AIRWORTHINESS DIRECTIVE

DG300 and DG300 Elan, All serial numbers.

For the Issue of an Australian Certificate of Airworthiness Each DG 300 type sailplane must comply with the following LBA approved Glaser-Dirks Technical Notes:-

TN 359/7, TN 359/8, TN 359/9, TN 359/10

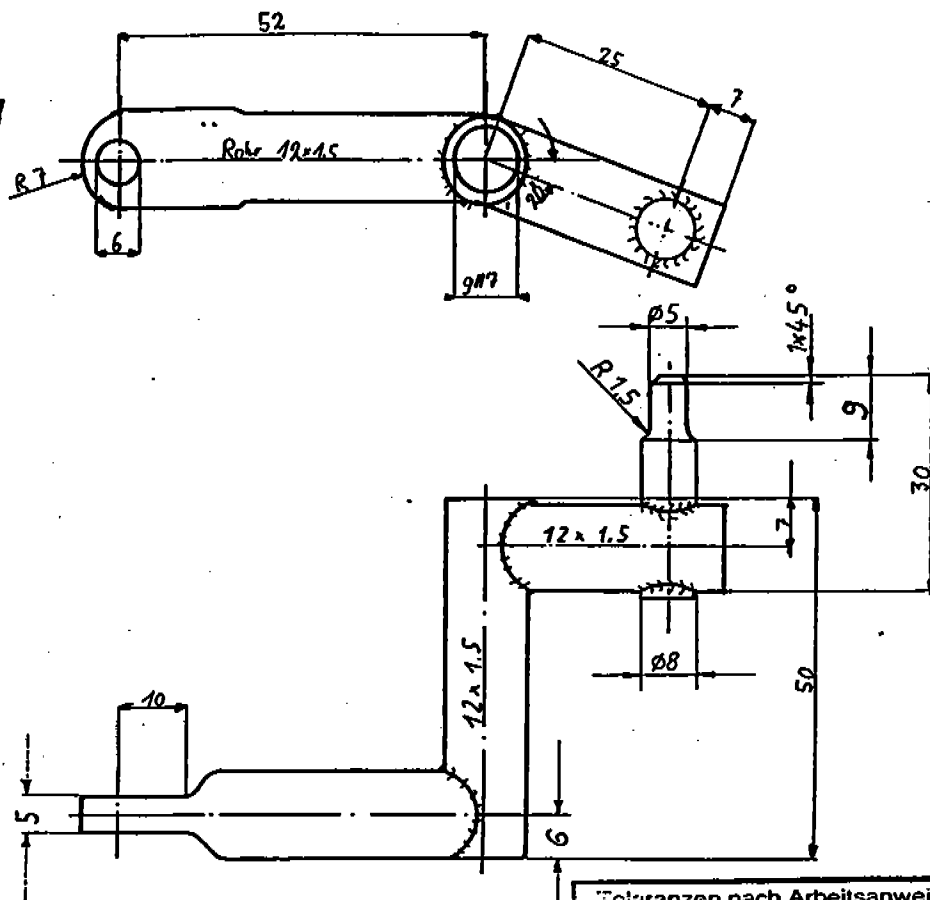
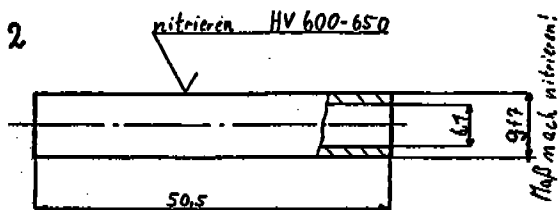
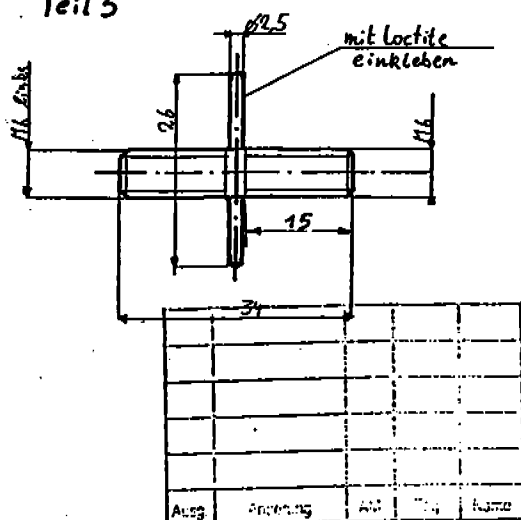
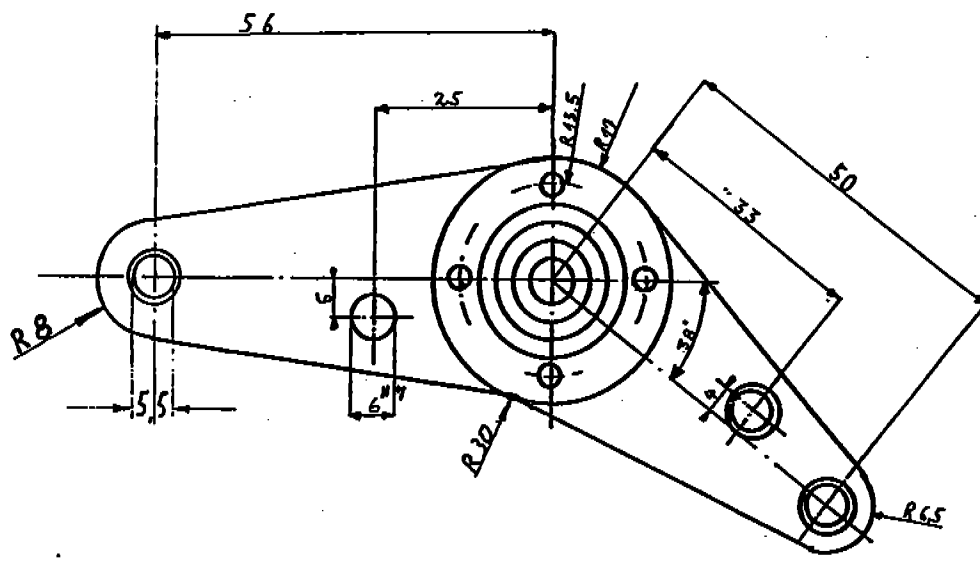
Assemble the bellcrank R80 provisionally with the clevis rod ends and the adjustmentscrew R79/3 to the bulkhead and the towhook. Adjust R79/3 for a distance of 75 mm (2.96 in.) of the axes. Insert the control cables with thimbles and Nicopress sleeves according to plan EFK and mark the positions. Take out the bellcrank R80 and press the sleeves with a Nicopress tool groove M (see also maintenance manual 4.2).

Adjust the adjustment screw R79/3 so that the cable leading to the C.G. tow release is just not tensioned. Lock the fork rod ends with the counter nuts. Glue in the rubber cover according to drawing R86 with Pattex contact adhesive or similar. Cover the joint with thin plastic tape.

Übersicht
Schleppkupplungs-
einbau E75

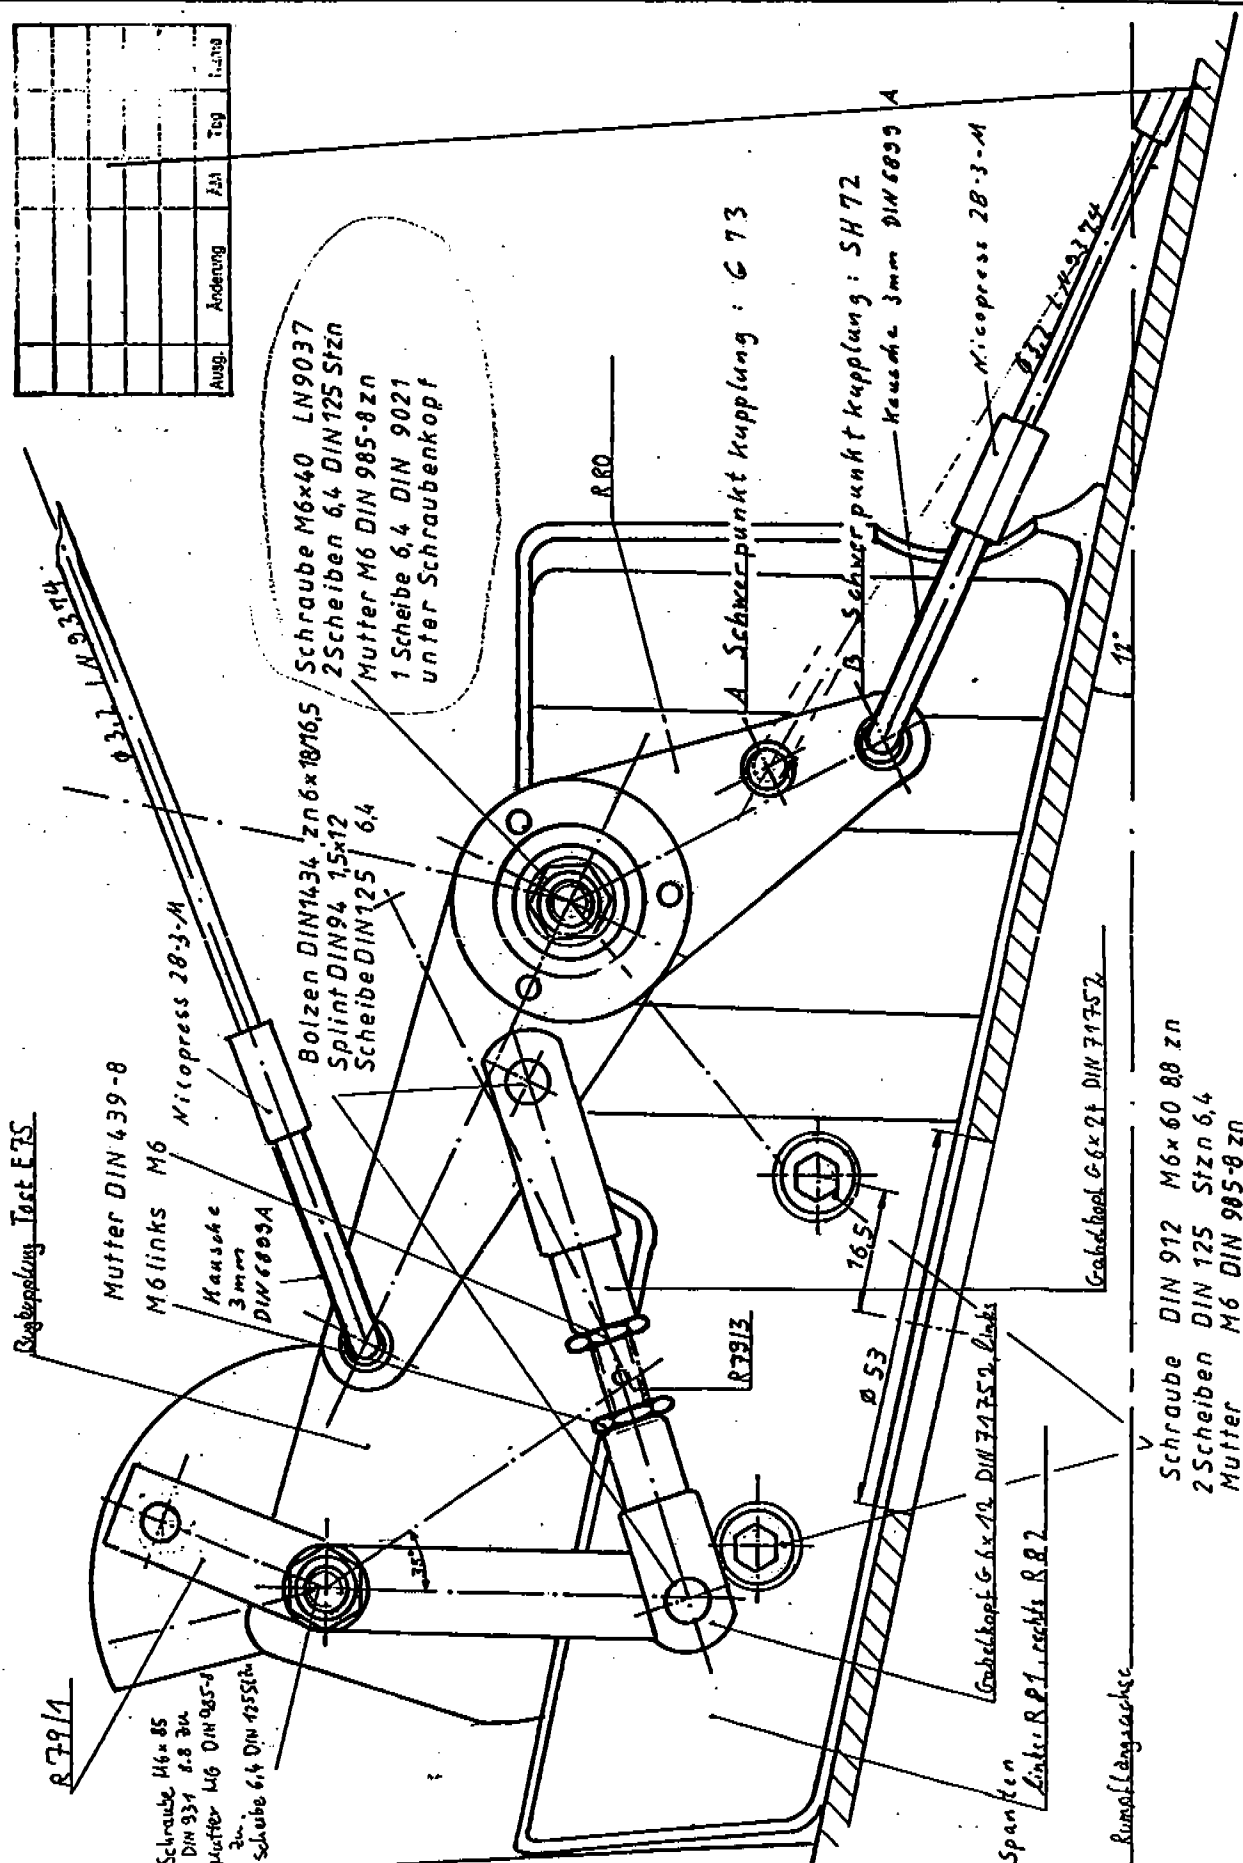
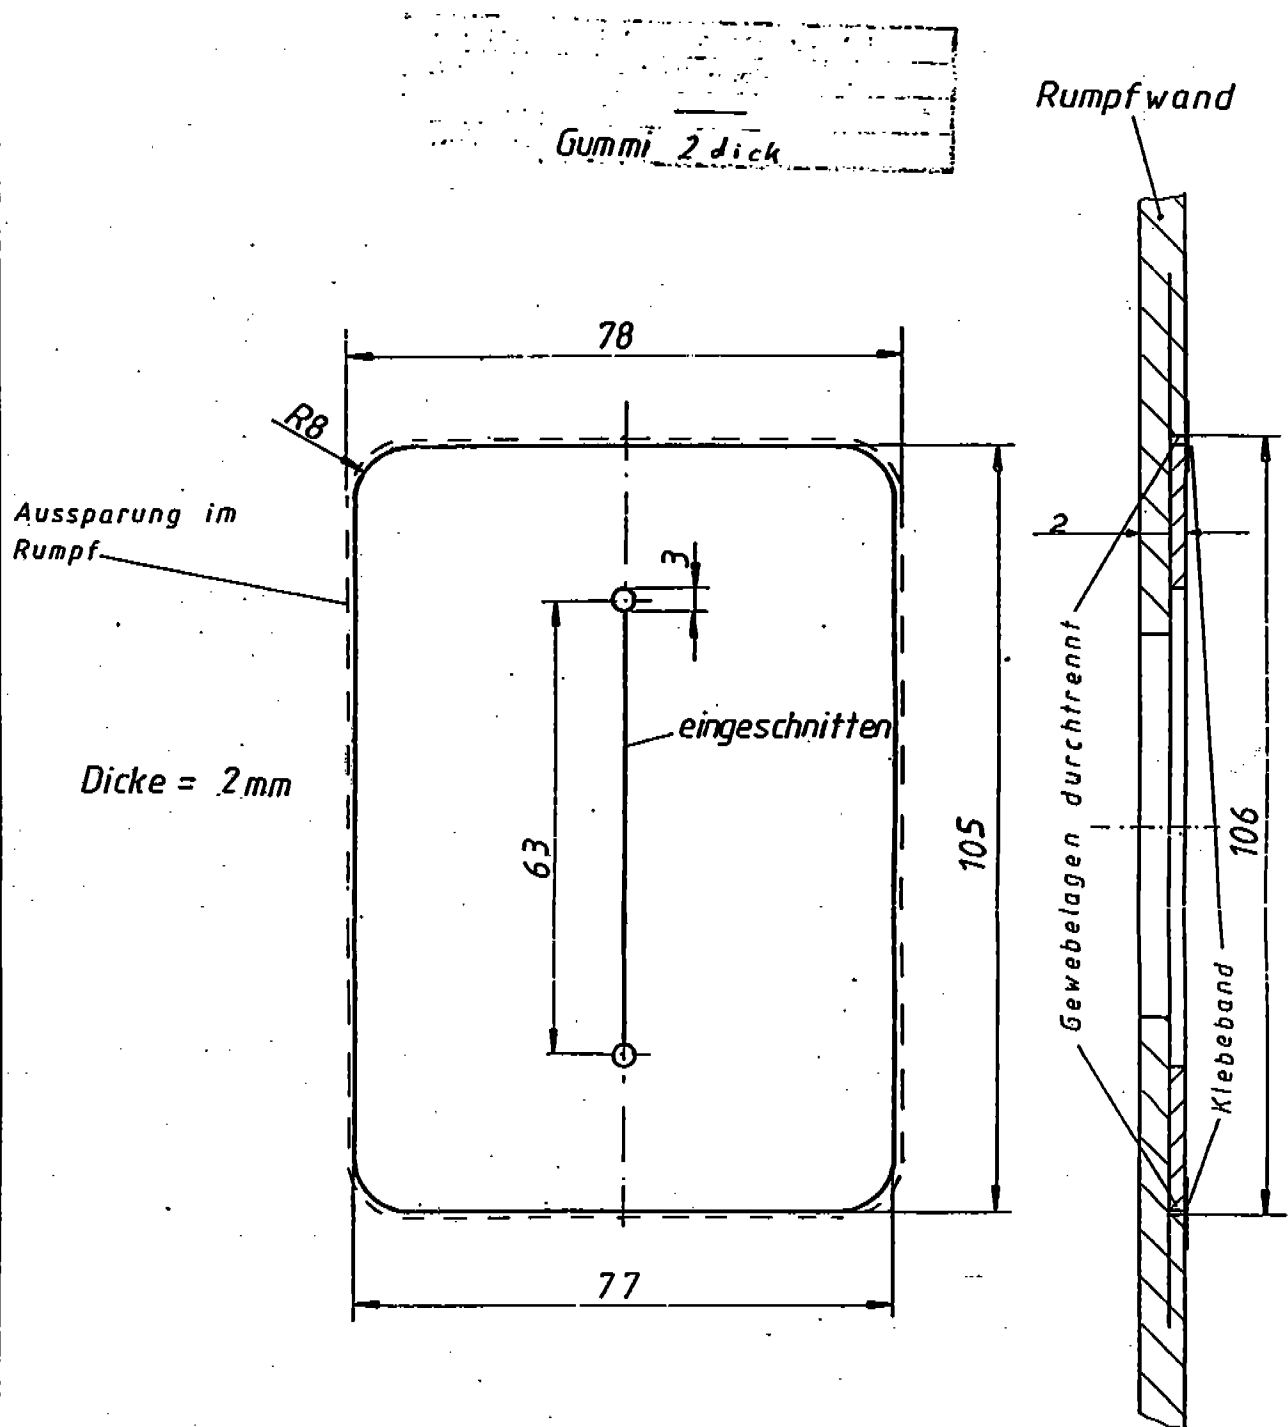
Instructions: 1. Installation of the nose tow hook Tost "E75" according to installation plan EFK, drawings R83 and R84.
For postfactory installation the installed control cable is to cut so that the cable leading to the C.G. hook can be used for the new installation. Cut the nylon tubes according to plan EFK. Remove the pulley and its cover under the instrument panel. Make a cutout in the left wall under the instrument console referring to drawing R84 for installation of the GFRP part R85. Grind away the upper and lower glued joints of the wall.

Assemble the bulkheads R81 and R82 provisionally to the tow hook. Place the assembly exactly in the middle of the fuselage and mark the position of the glued joints for the bulkheads and a cutout diameter 53 mm (2.1 in.) for the ring of the tow hook see drawing R83.

Next you have to alter the position of the pitot and static pressure lines according to installation plan ED/1. The lines should come out of the GFRP wall min. 90 mm (3.5 in.) above the fuselage bottom. If not, you have to reposition them prior to the installation of the tow hook.

Roughen the glued joint areas at the bulkheads, the fuselage and the wall R85. Assemble the tow hook with the lever R79/1 and the bulkheads.

Mix the resin 50 g (1,76 ounces) GE 162 and 19 g (.67 ounces) hardener Laromin C 260. Brush all glued joint areas with the resin mixture. Thicken some of the resin mixture with cotton flocks and apply on the glued joint areas. Glue in the wall R85 and the bulkheads with the towhook. Fix the nylon tubes according to plan EFK with 2 layers of glassfibre fabric 92125.

R. 19

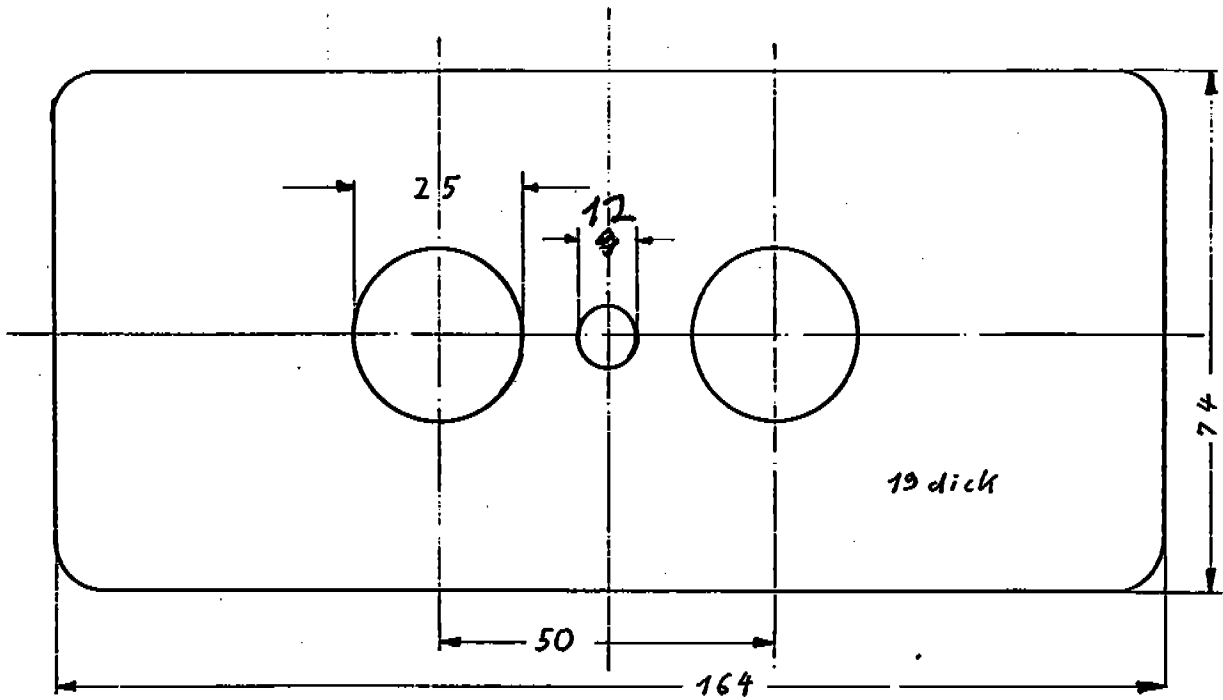
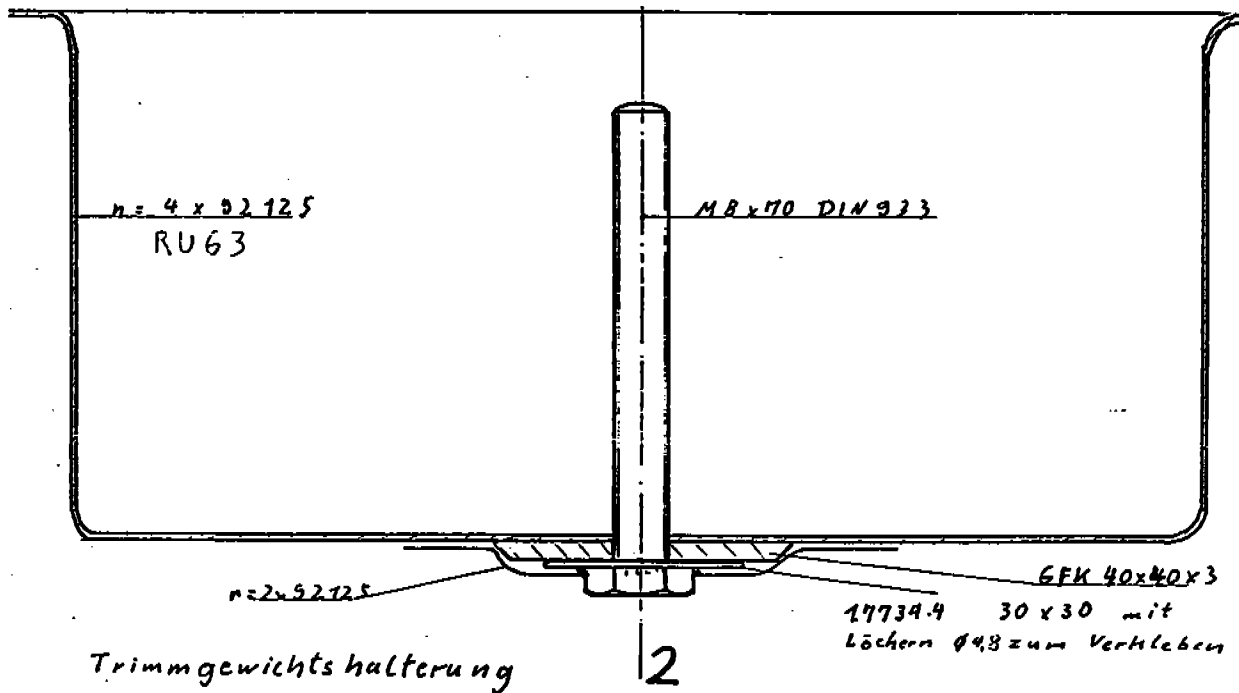
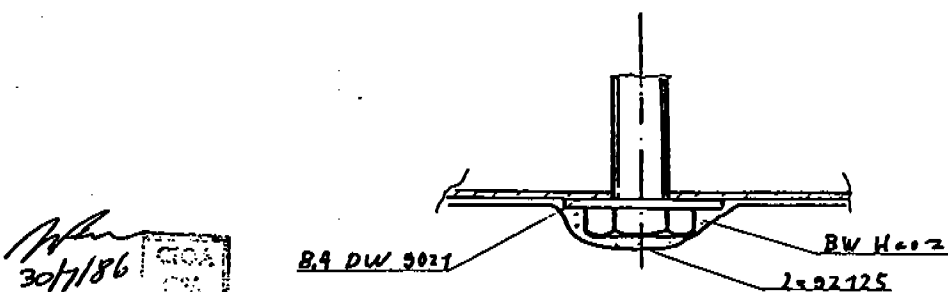
d) Installation of a trim weight box according to drawing

R 19 at the right hand side of the instrument console

as installed originally in the DG-100.

e) Use of the trim weights part R 19/1 min. 2.2 kg each.
